Agenda

Thursday, April 7, 2022; 7:00 p.m.

PLAN FOR APPROVAL

Regular Agenda

Figure 1 - Proposed fence location.

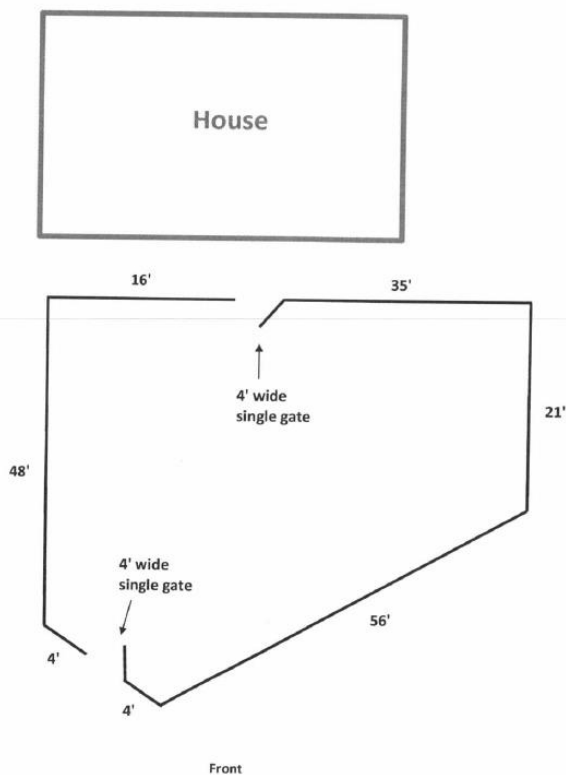
Scope of Work: The Applicant proposes to install a 4-foot tall black aluminum fence around the front yard. The fence will have two gates, as shown in the site plan, on opposite sides of the fence perimeter.

The Guidelines show an example of the proposed fence in a graphic of appropriate fence styles for the district. However, the Guidelines also indicate that a less formal type of fence, such as a split rail or post and rail fence is appropriate in less densely developed areas such as Sylvan Lane and that simple picket fences are appropriate for smaller, less formal homes. The architectural style of the existing home is a 1950s rancher, that was updated in 2018. While it is not common to find a fence enclosing a front yard in this area, the Commission approved a wooden cross rail fence, to be stained black, in October 2020 on Upper Church Road (HPC-20-69), which is another area in the district that is less densely developed.

Staff Recommendation to the HPC: Staff recommends the HPC determine if the proposal complies with the Guidelines and approve, modify or deny accordingly.

Figure 10 - Original signage, circa 1930s/40s

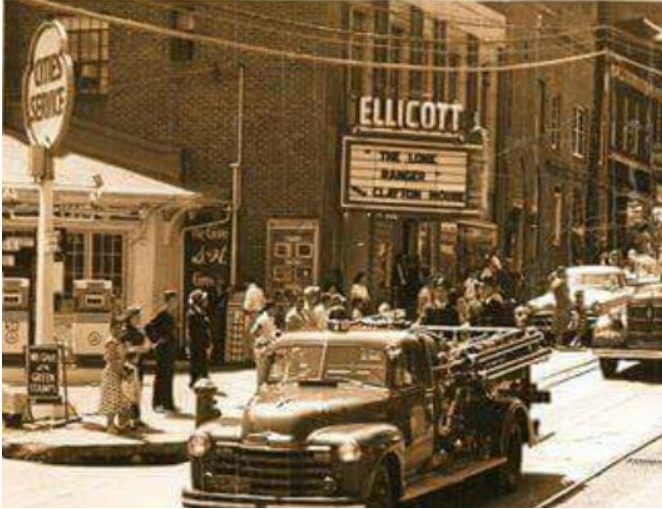
The main marquee sign served as the former Theater marquee (see Figure 10). The Applicant proposes to install the main business sign here, which will read:

Figure 15 - Proposed use of signage on marquee.

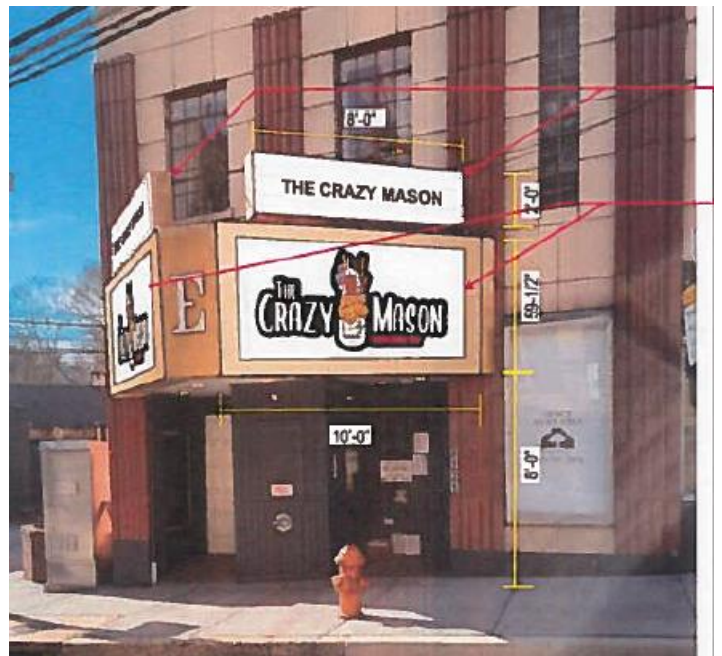
The marquee sign will contain more than three colors, primarily within the graphic of the milkshake and for the term "milkshake bar", otherwise the text will be white with black outline on the marquee sign.

The changeable sign board above the main marquee sign was originally used to advertise theatrical events; however, is now being proposed to be used to advertise new milkshake flavors, etc. The Commission should determine if this complies with the Guidelines. The Applicant said the letters will be 6” changeable numbers and letters in a serif style font, similar to what has previously been on the marquee. If approved, the business owner would be able to change out the message as routine maintenance per Chapter 11.A.

The marquee sign fits within the existing theater marquee, and as a result is larger than typically recommended.

Staff Recommendation to the HPC: Staff recommends the HPC determine if the signs comply with the Guidelines and approve, deny or modify accordingly.

Figure 16 - Proposed projecting sign above storefront windows.

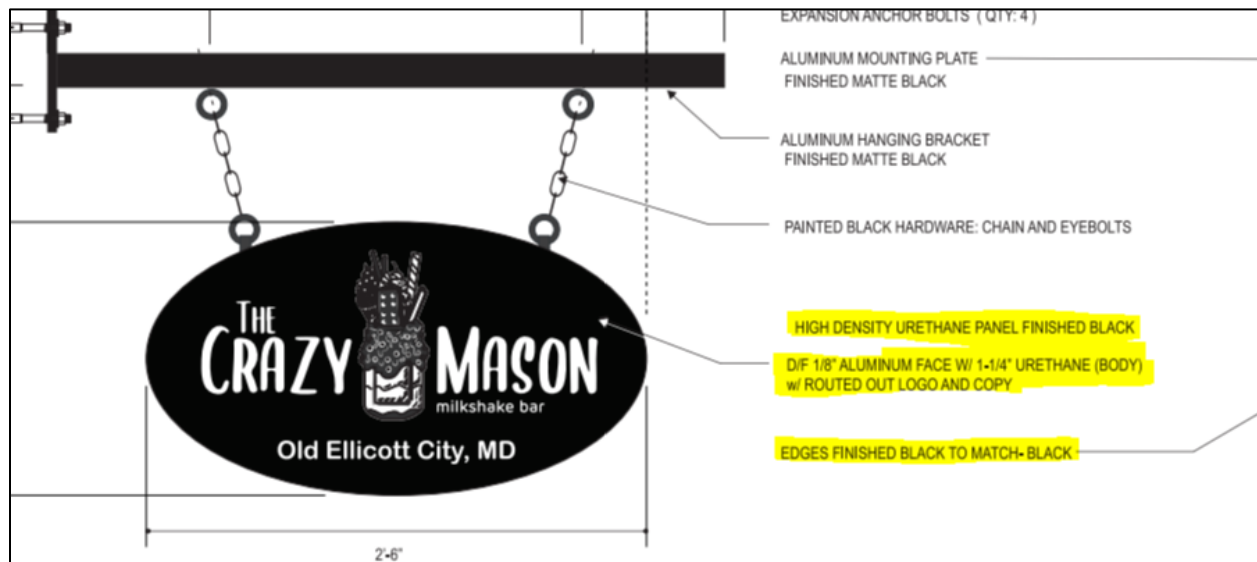
The marquee sign involves the re-use of a historic sign on the building. The projecting sign to be located above the storefront windows will be high density urethane (HDU), which the Commission has previously approved as it has the thickness and texture of wood, and the ability to be routed and sandblasted like wood, but is more suitable for long term use outside.

The projecting sign above the storefront windows will be 3.41 square feet and complies with the Guideline recommendations.

Figure 25 - Proposed paint color for siding and trim.

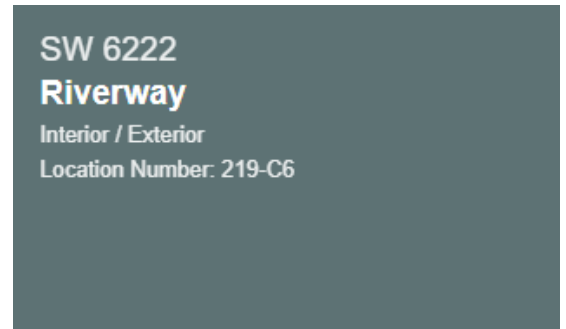
The proposed paint color is similar to the existing color, and is compatible with the historic stone structure.

Figure 31 - Proposed new addition, west elevation.

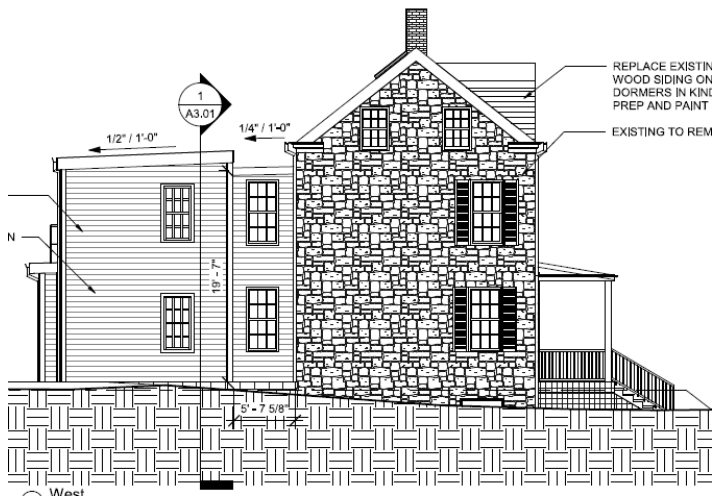
The addition is proposed on the side and rear of the building, but it will be visible when approaching the building from the front driveway. The HPC should consider how the addition appears from all views of the building and determine if the proposed 2-story addition appears subordinate to the historic building and does not compete with or obscure the historic structure.

The addition will be two stories tall behind the main portion of the historic structure and one-story tall behind the two-story portion. Per the drawings, the proposed addition appears to cover the entire two-story rear of the historic stone building, obscuring parts of the rear of the building that have previously not been obscured. However, as recommended by a Commissioner at the February HPC meeting, the height of the addition has been lowered slightly to sit below the cornice line of the historic house.

The HPC should determine how well this design complies with the guidelines listed above and found in Chapter 7.A.

Figure 35 – Current proposed rear (north) elevation. Door will line up with above window.

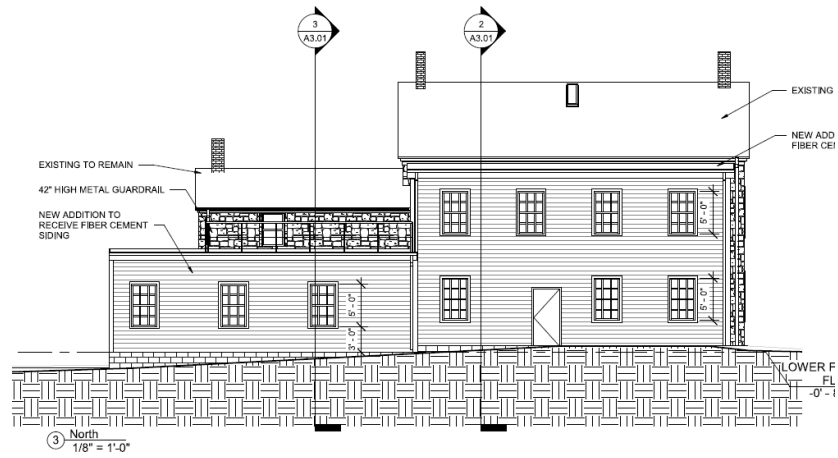
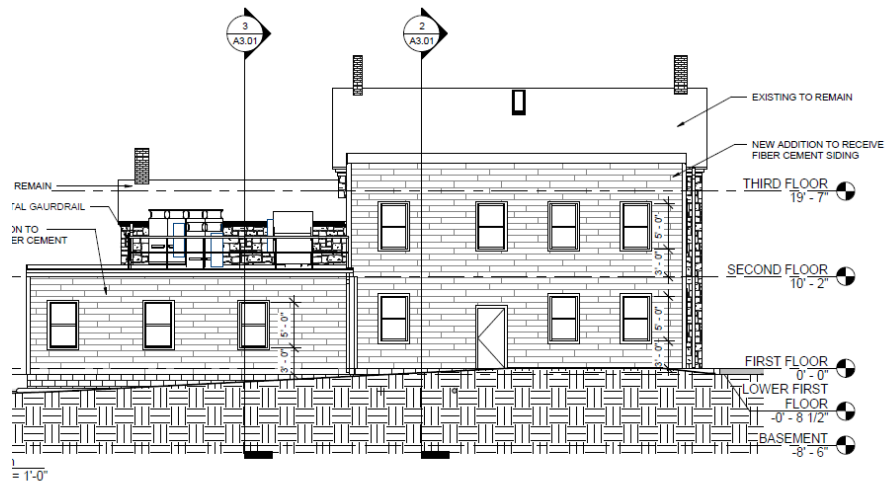
The proposed new addition design has been updated with a sloped roof that is now pitched away from the historic house. The existing historic house and existing east side addition have a gable roof.

Figure 40 - Proposed parking area.

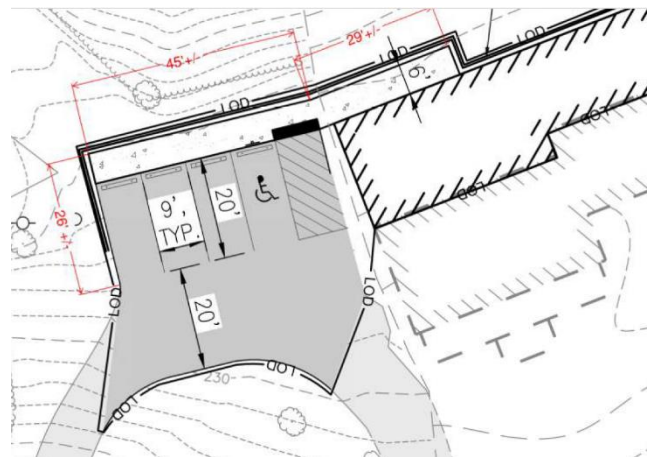
The proposal to make the parking area asphalt will be consistent with all public parking areas.

While the parking area will be formally created and striped, the existing driveway provides for a parking area currently, so it will not substantially alter the setting.
